Quality Control Check Report. Stage: After Finishing Stage II (Apartments)

Flat No	A-1001	Other	SI. No.	38139
Company	MPL	Project	Phase	-
Prepared by	T. Vinod Kumar	Sign	Date	09-08-21
Project Manager	Subba reddy	Sign	Date	09-08-21
Previous stage report no.	37664	MD Sign	Report filed and signed by PM	<input checked="" type="checkbox"/> Yes <input type="checkbox"/> No
Checked By MD on		MD Sign	For filling	<input type="checkbox"/> Yes <input type="checkbox"/> No

Details of Additions & Alterations

Flat No	1001	Block no.	'A' ✓
Flat Area	1500 sft	Type	Deluxe / Luxury
Buyer Name	Sajja Mohan Srinivas Ravindra / Tirumalamba		
Phone No.	+919000268885/ +919849075964	Email	RAVINDRA SMS @ GMAIL . COM

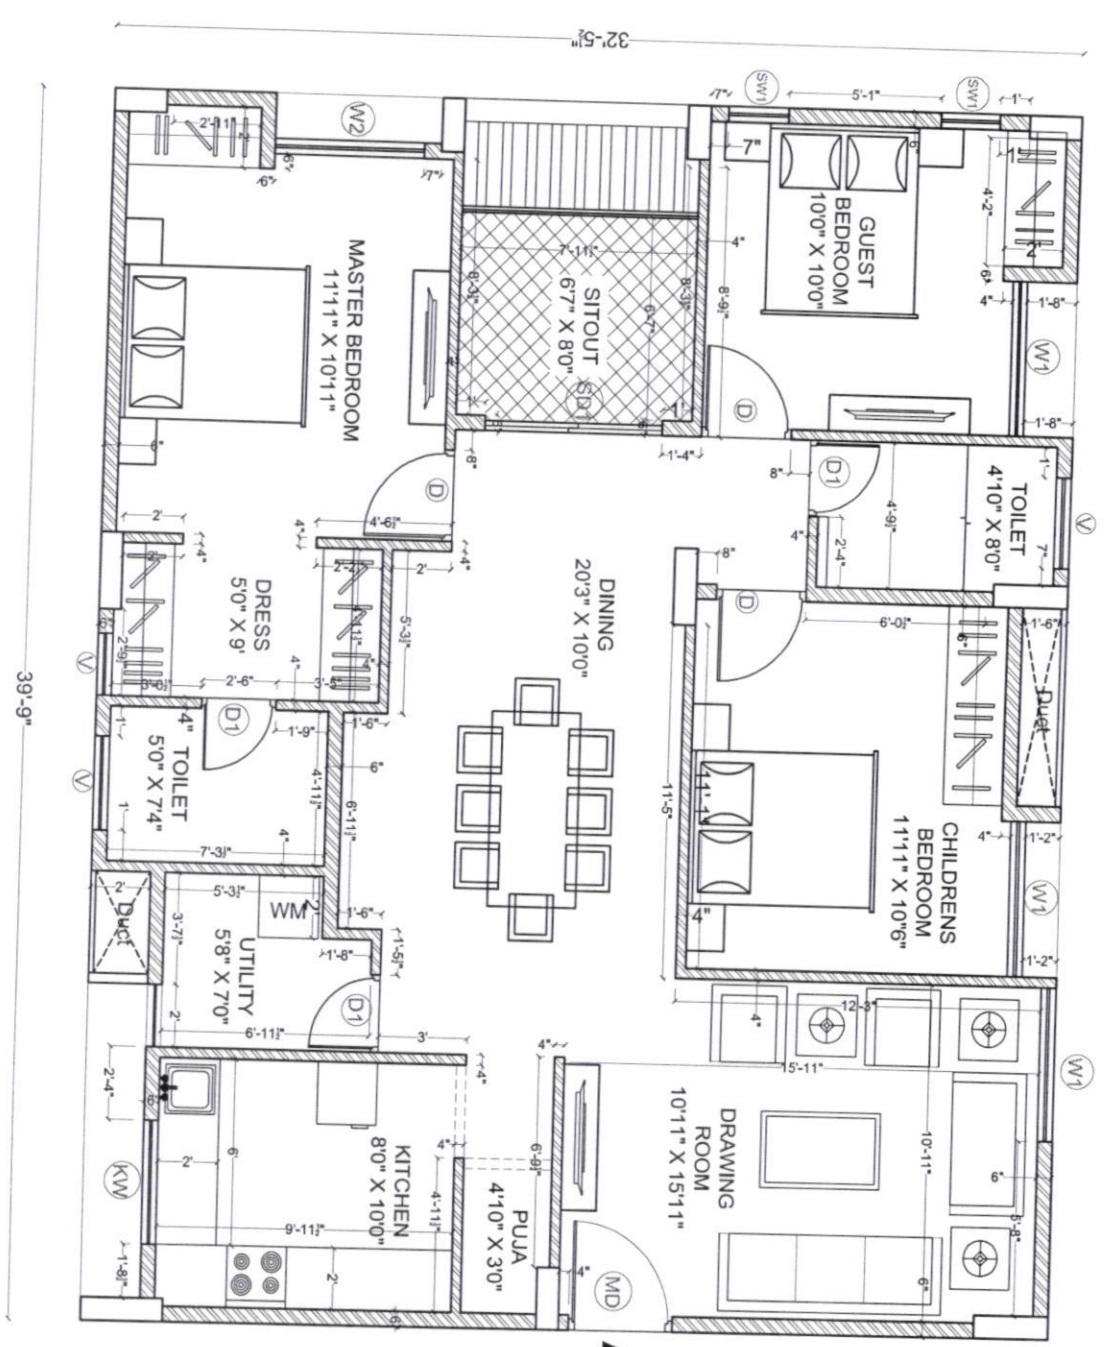
Changes in kitchen platform: (mark on plan)

① Extension of platform (marked on plan)

Other Changes: ① Wall to be removed at kitchen
entrance (marked on plan)

ELECTRICAL PLAN OF FLAT-A1

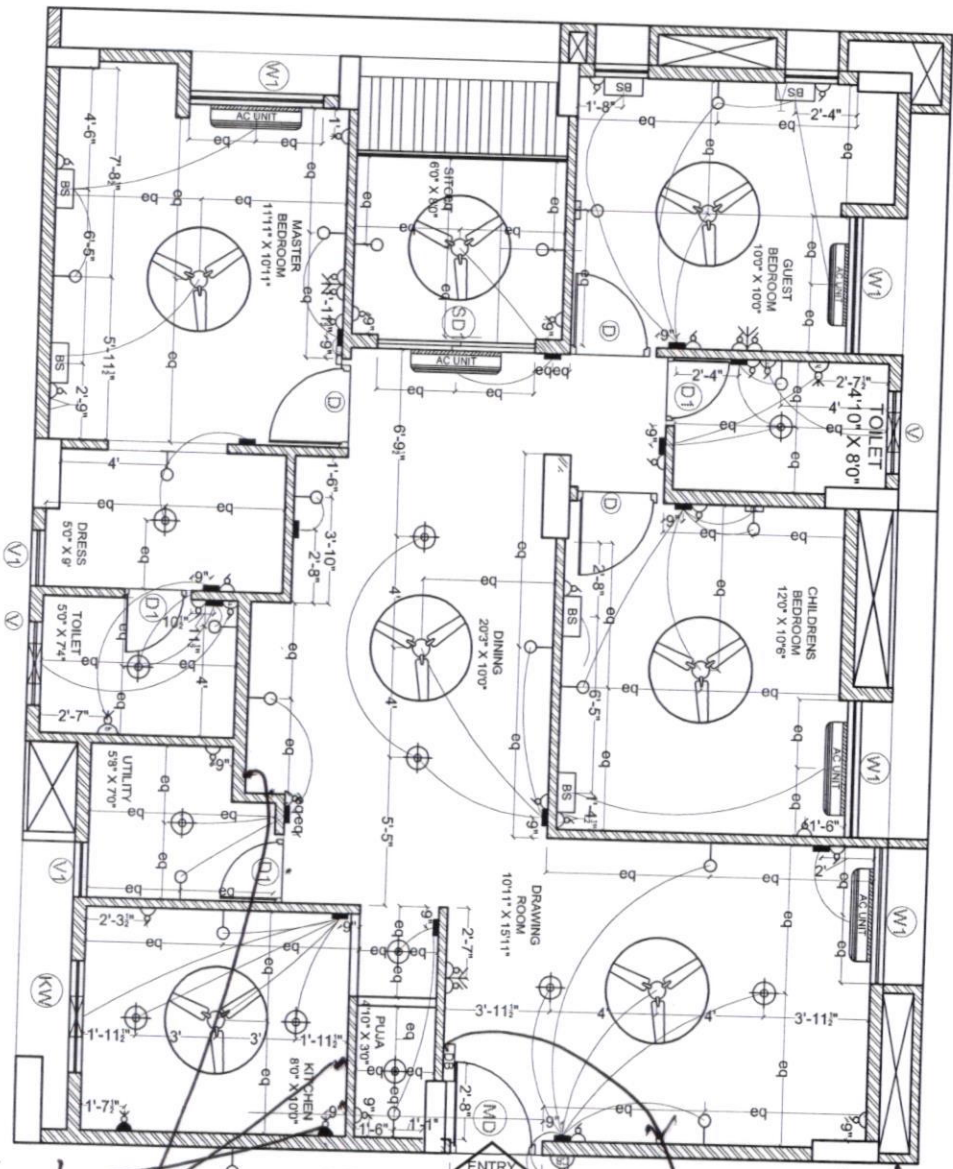
- ① 15amps pt. in dining hall (marked on plan)
- ② Shifty of fridge pt in kitchen (")
- ③ 5 amp pt to be shifted down on north east corner

*To be shifted down 8 mtr F
 15amp pt for fridge*

Entered TV pt to be shifted

PLUMBING PLAN OF A1

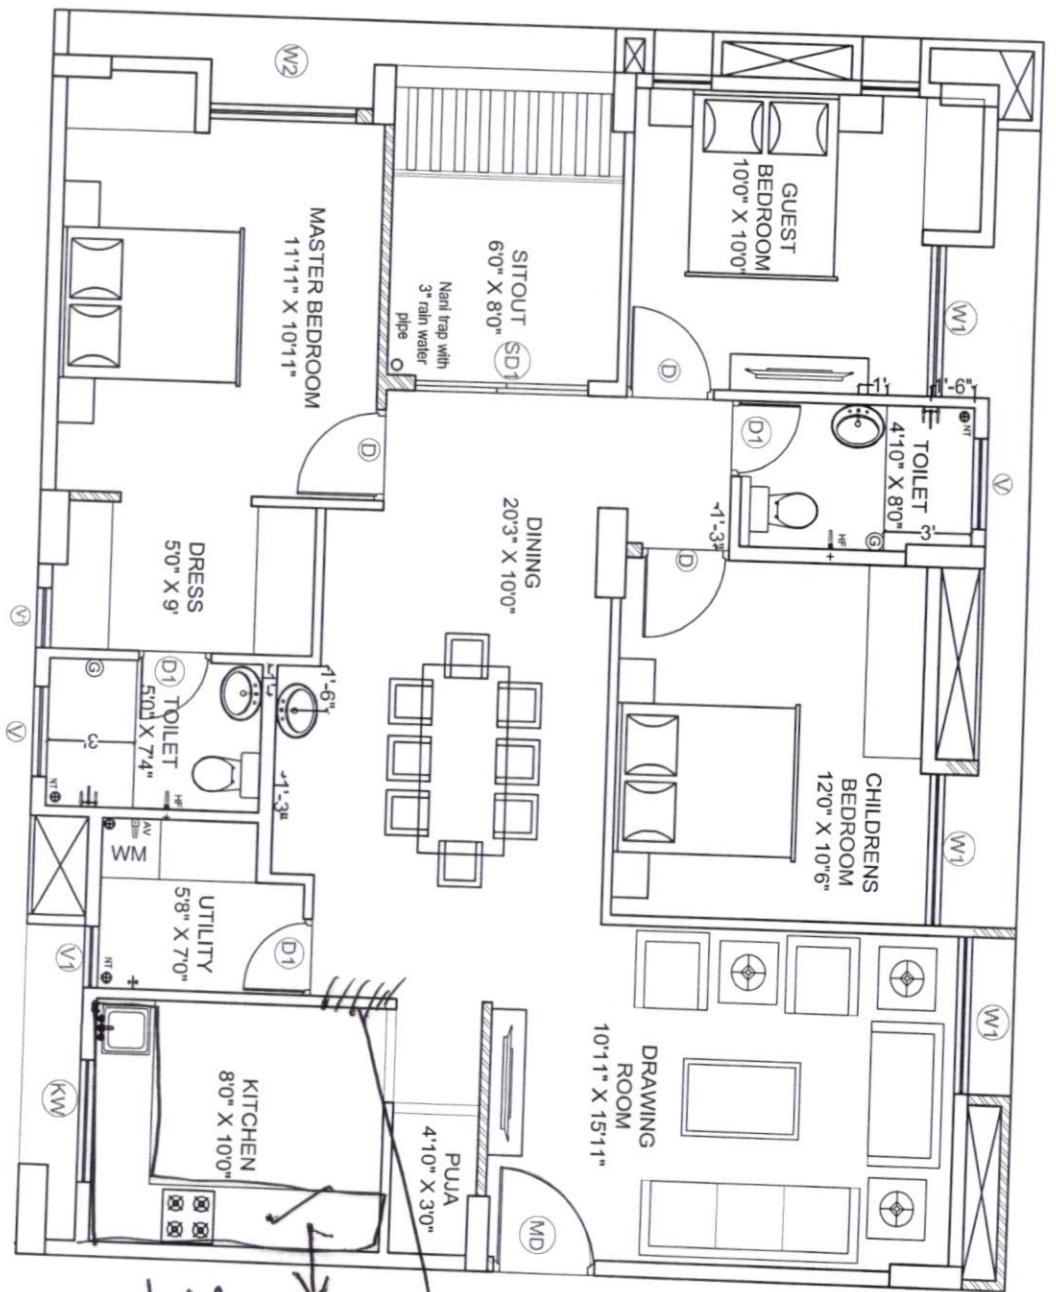
platform
to be removed A1
